Model: Apollon-C1 ARDF DF3010		Date: 28-May-08	No.: MB802001
Modified Article: TAPPING SCREW - 3X6		Prepared by: N. Yoshida	
From: 2nd Tech. Support Sec. Service Support Dept.			
Reason for Modification:	<input type="checkbox"/> Parts catalog correction <input type="checkbox"/> Vendor change <input checked="" type="checkbox"/> Other <input type="checkbox"/> To facilitate assembly <input type="checkbox"/> To improve reliability <input type="checkbox"/> To meet standards <input type="checkbox"/> Part standardization <input type="checkbox"/> Product Safety ()

Model: Apollon-C1 ARDF DF3010		Date: 3-Jun-08	No.: MB802002
Modified Article: GUIDE:EXIT:UPPER:SUB		Prepared by: N. Yoshida	
From: 2nd Tech. Support Sec. Service Support Dept.			
Reason for Modification:	<input type="checkbox"/> Parts catalog correction <input type="checkbox"/> Vendor change <input type="checkbox"/> Other <input type="checkbox"/> To facilitate assembly <input checked="" type="checkbox"/> To improve reliability <input type="checkbox"/> To meet standards <input type="checkbox"/> Part standardization <input type="checkbox"/> Product Safety ()

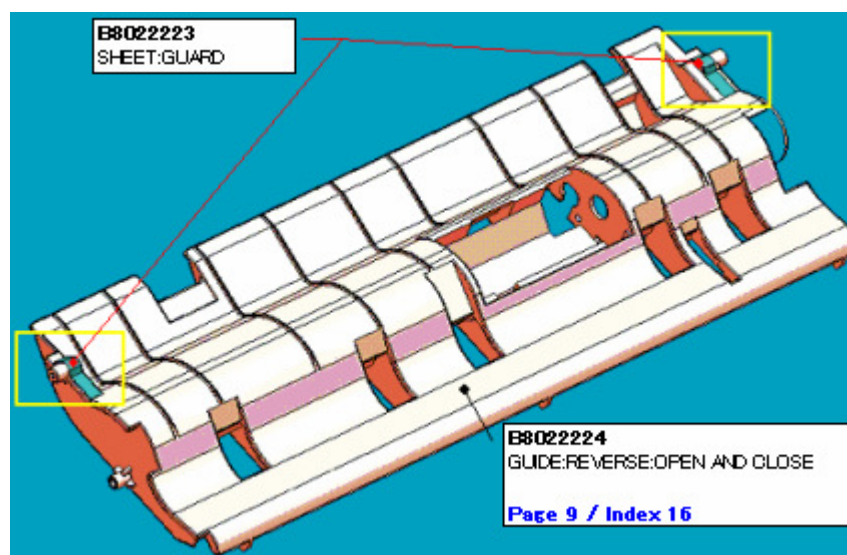
- Note:** 1) The page and index information were added.
 2) New index number is added because the following part number "B8022223" is not listed.
 3) The illustration for B8022223 (Sheet:Guard) was added.

Old part number	New part number	Description	Q'ty	Int	Page	Index	Note
B8022222		GUIDE:REVERSE:OPEN AND CLOSE			9	16	A
B8022223		SHEET:GUARD					A
B8022231		SHAFT:REVERSE:DRIVE:PRESS FIT			9	20	A
B8022285		ROLLER:REVERSE EXIT:DRIVEN			9	19	A
	B8022220	GUIDE:REVERSE:OPEN AND CLOSE:SUB-ASS'Y	0-1			*	A
B8023651	B8023650	GUIDE:EXIT:UPPER:SUB-ASS'Y	1-1	X/O	15	20	A
B8023650	B8023655	GUIDE:EXIT:UPPER:SUB-ASS'Y	1-1	X/X			A

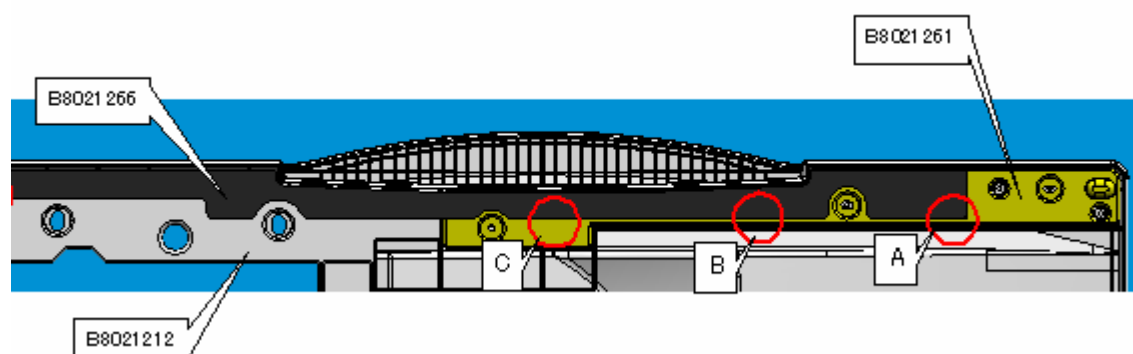
The three parts were added to make the product more safe.

The shape of "frame: base (B8021211)" was changed to B8021212.

"Grip: lower (B8021261)" and "sponge:base:2mm (B8021266)" were attached to "frame: base".

Old part number	New part number	Description	Q'ty	Int	Page	Index	Note
	B8021212	FRAME:BASE	0-1			*	A
	B8021261	GRIP:LOWER	0-1			*	A
	B8021266	SPONGE:BASE:2MM	0-1			*	A
B8021312	B8021313	HINGE:LEFT:ASS'Y	1-1	X/X	23	8	A

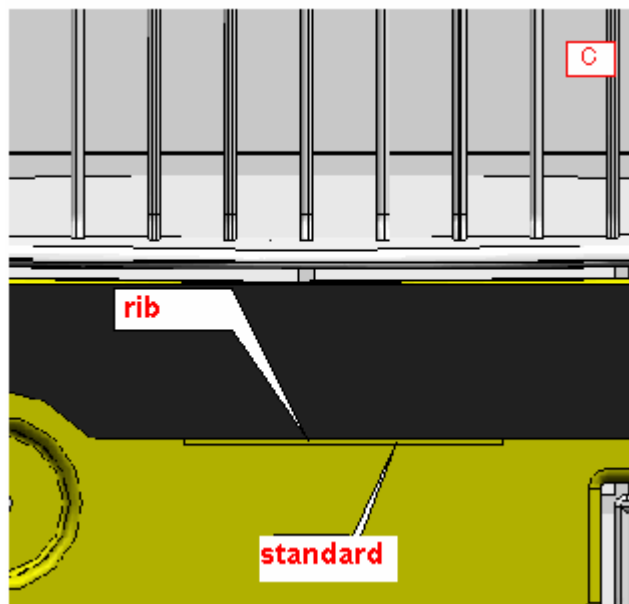
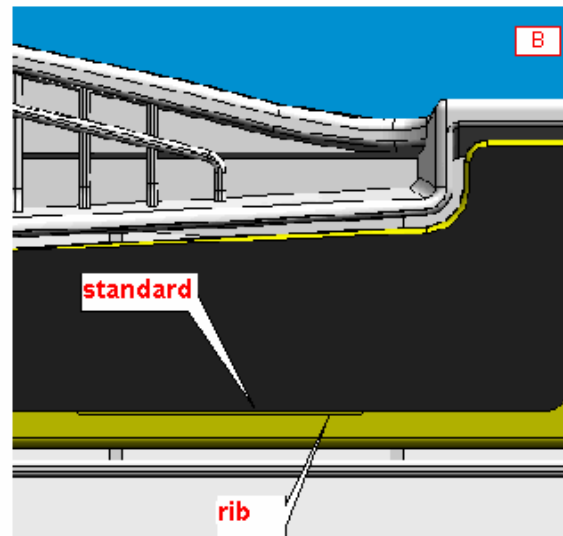
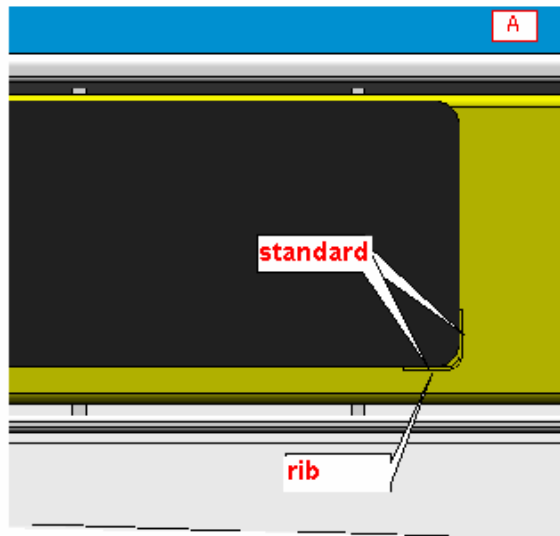
Their attached locations are shown below.
